File 1992-0027

Name: High Fashion Fabrics - Rezone & Final Plan

Accompanying is a Zone Change Request and Development Plan for a new retail business location for Hi-Fashion Fabrics. The requested change in zoning is from RSF-4 to PB "Planned Business". The subject site is located on approximately 2.1 acres northwest of Patterson Road and Meander Dive, 660 feet west of North 1st. Street.

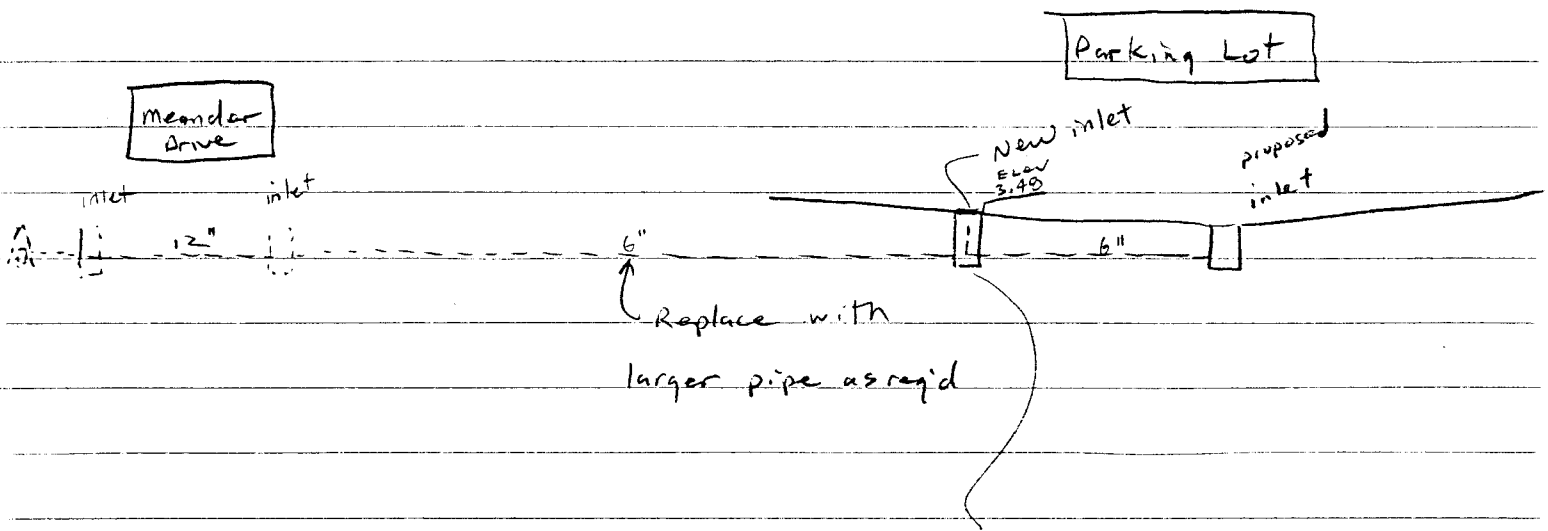
CONCLUSION: The designed system does not match the calculations; That is, 1.0789 cfs average cannot be achieved, which is what the volume calcs are based upon. With the current design, the outflow is less, therefore the volume will be more, and the depth of ponding increased. Criteria only allows 1.0' of ponding on parking areas. If the design worked per calculations (which it does not), the 1.0 foot would be exceeded. However, as the current design is, it is probable that the depth would approach 1.75' feet. That is unacceptable.

We suggest looking at the following:

$$Q_0 = 0.9 \text{ cfs} \therefore \text{Avg } h = (3.76 - 3.40)(1.67) = 0.19'$$

$3.62' = p \rightarrow$  Grate opening is subject to clogging, and should not be used to meter outflow. Figure 50% clogging, use grate with  $p = 3.62 \times 2 = 7.2$ .

DETAIL SHEET

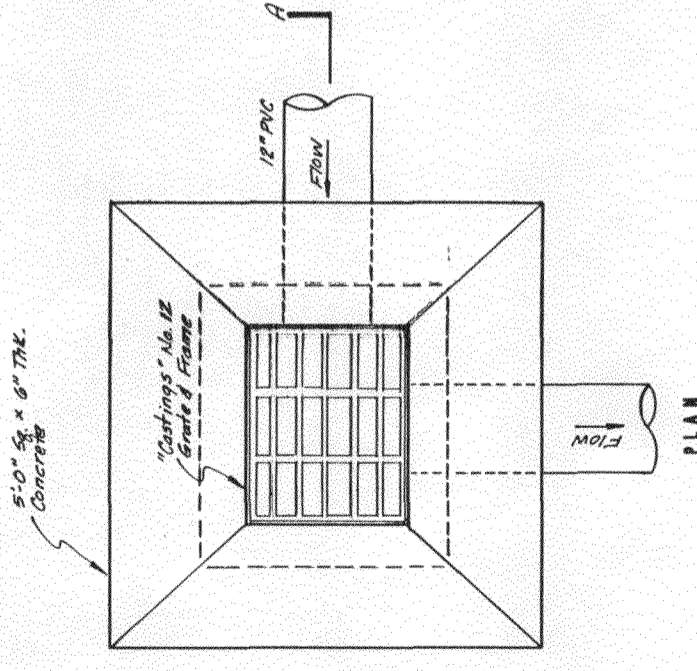
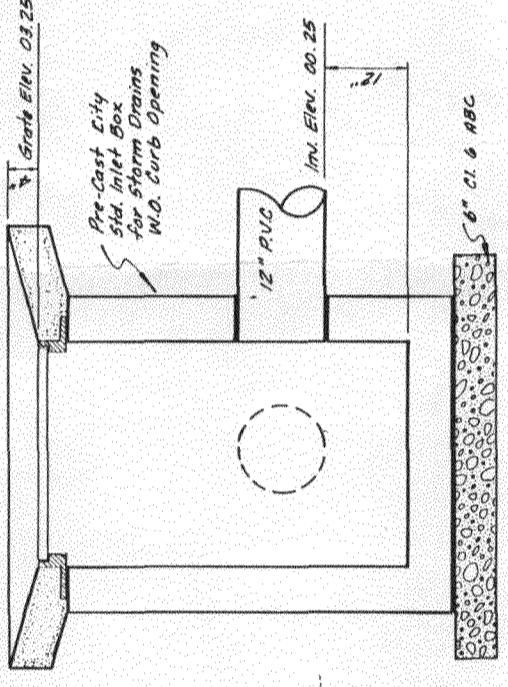
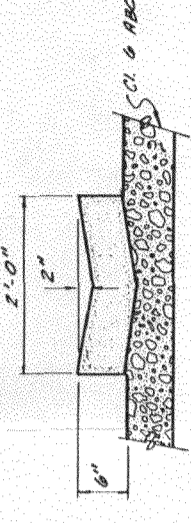
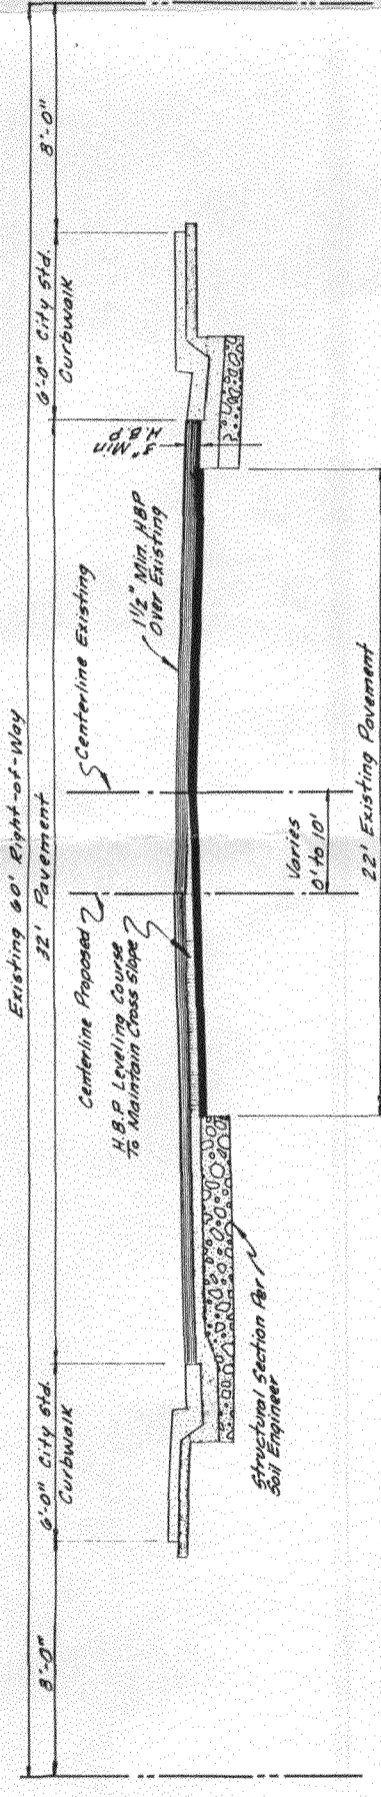
7. On the drain trough detail, much definition and grading is lacking. There is a sidewalk behind the building which connects to public sidewalk. The cross-section shows that the private sidewalk dips down and goes underneath the other sidewalk. It would appear that part of the private sidewalk would and should remain at the elevation of the back of the public sidewalk. However, grading and slope information is lacking on the detail.

9. The grate elevation shown in Section A-A is at 3.23 feet, and on the grading plan it is shown at 3.25 feet. These should be consistent.
10. There is a note on the street section that the base should be per the soils engineer's recommendations. We had indicated before that these were final plans, and information from the soils engineer should be on the plans. Note that 6 inches is a minimum.

12. On the detail of the 4 foot walk and curb, it shows a 5 foot drainage and slope easement. This has been changed to 15 feet on the plans and grading plan. Also please change the easement to be a drainage, utility, and slope easement.

4. All grades, slopes, and contours have been double checked to insure a minimum of 1.0% slope on all paved surfaces.
5. Additional detail information for the Drain Trough near the southwest corner of the site have been added to Sheet 5.
